W3F1-97-0270
A4.05
PR

December 12, 1997

Subject: Waterford 3 SES
Docket No. 50-382
License No. NPF-38
Request For Additional Information (RAI) Regarding
Technical Specification Change Request NPF-38-193

**ADDITIONAL INFORMATION REGARDING TECHNICAL SPECIFICATION
CHANGE REQUEST NFF-38-193**

ATTACHMENT 1: WATERFORD-3 CASK PIT DECAY HEAT VARIATION WITH TIME

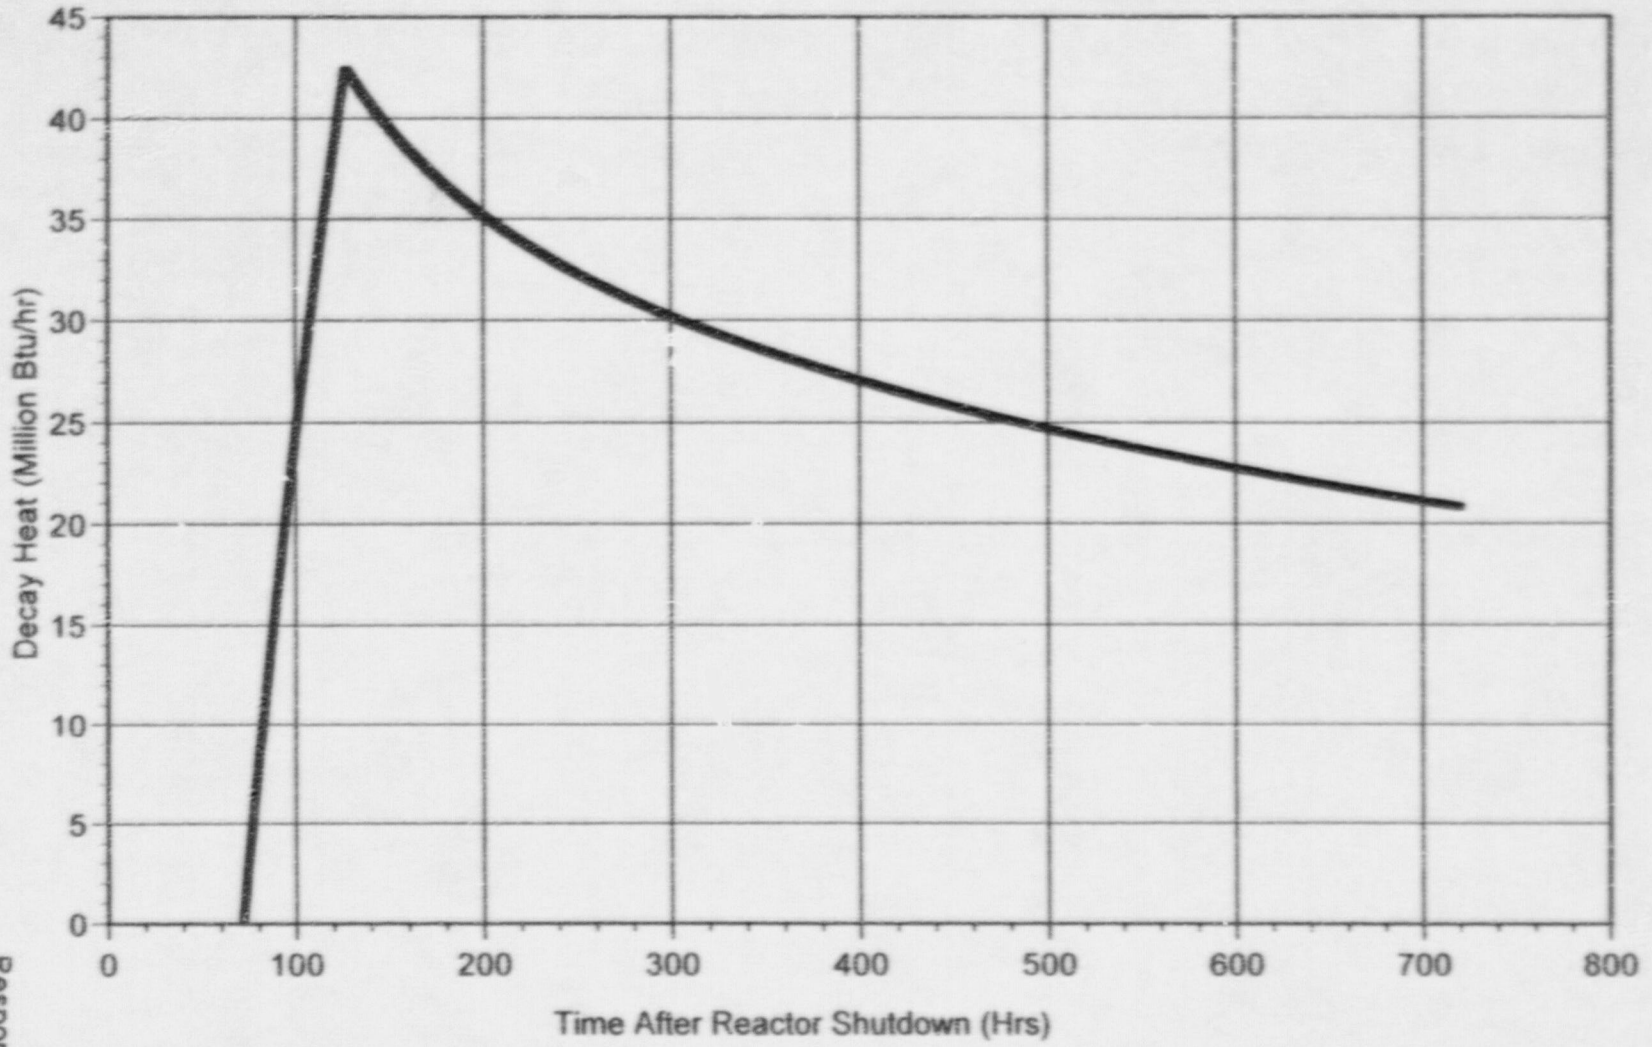
- * Decay heat generation rates from the spent fuel assemblies stored in the Cask Storage Pit and the Refueling Canal as a function of time.
- * Cask Storage Pit and Refueling Canal water temperature as a function of time.

The time variation of the decay heat from the fuel assemblies stored in the Cask Storage Pit is shown in the figure provided in Attachment 1. The decay heat load in the Cask Storage Pit consists of the decay heat from 217 freshly discharged assemblies and 38 "old" or previously discharged assemblies. The corresponding curve for the Refueling Canal is presented in the figure provided in Attachment 2. The decay heat

Response to Questions on
 Technical Specification Change
 Request
 NPF-38-193
 ATTACHMENT 5

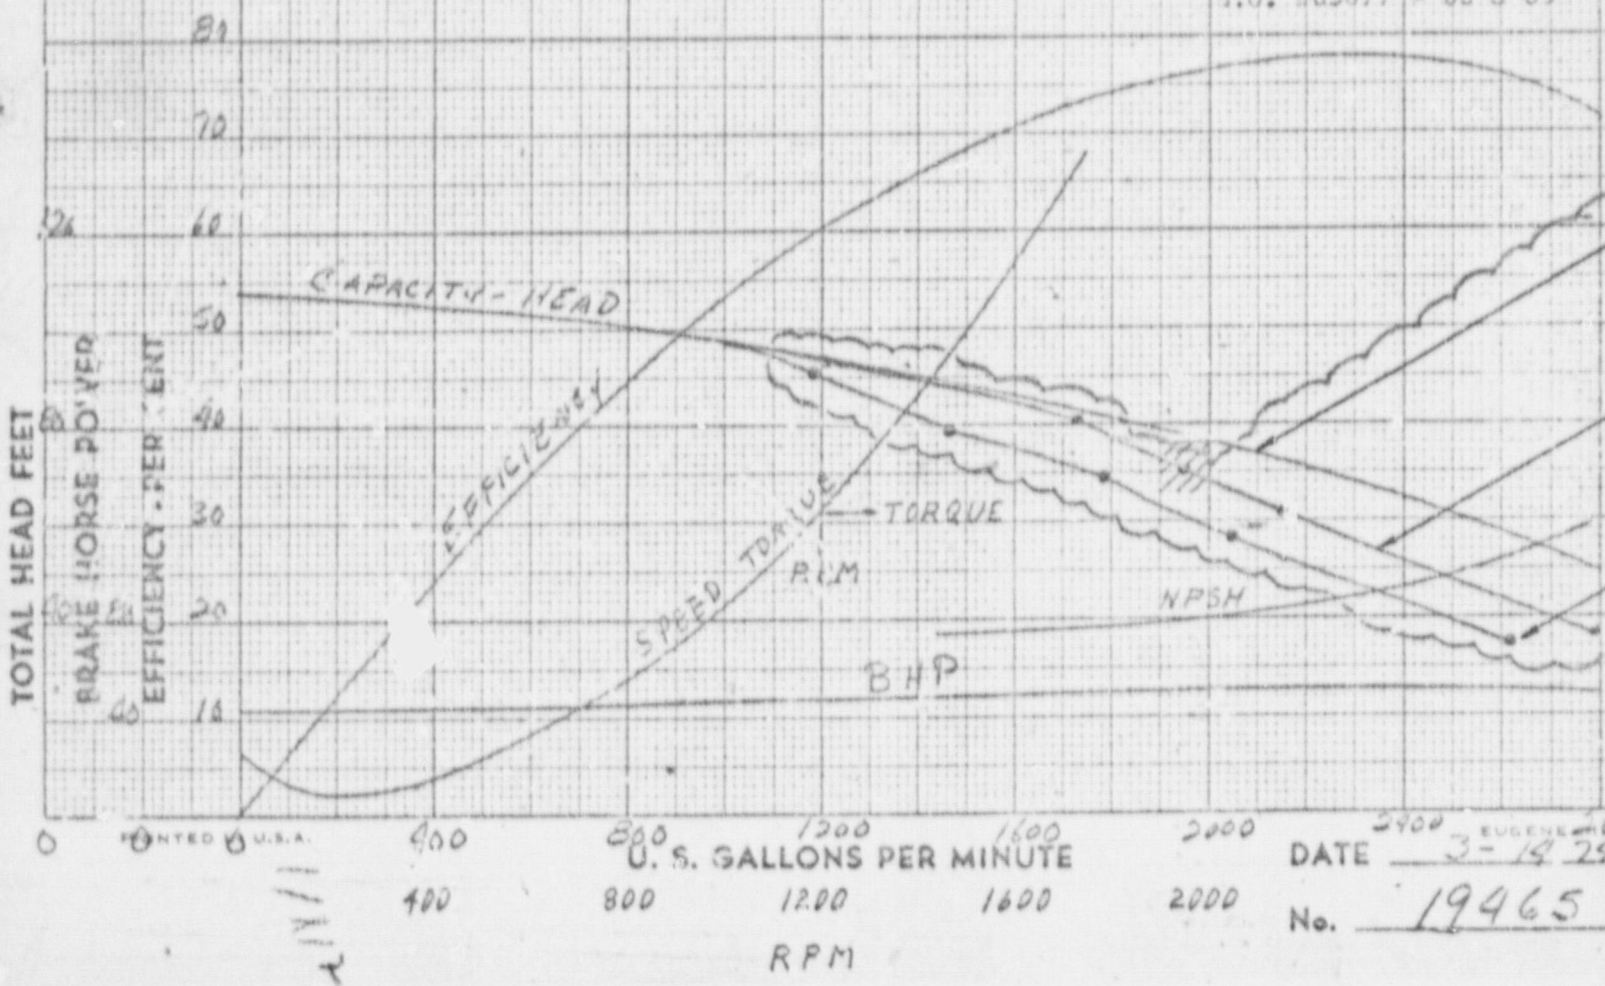
- * Detailed description of how the decay heat generated from the spent fuel assemblies stored in the Cask Storage Pit and the Refueling Canal will be removed. Information should include: cooling system design parameters, equipment redundancy, seismic category, etc., and drawings to show cooling system configuration.

A drawing showing the Spent Fuel Pool cooling system configuration is provided herein as Attachment 4. The pump head/flow curves are provided herein as Attachment 5. The data sheets for the primary and backup heat exchangers are provided herein respectively as Attachments 6 and 7. Component cooling water at a maximum temperature of 90°F is supplied to the shell side of each heat exchanger. The component cooling water total maximum flow, for fuel pool cooling, is 5000 gpm.
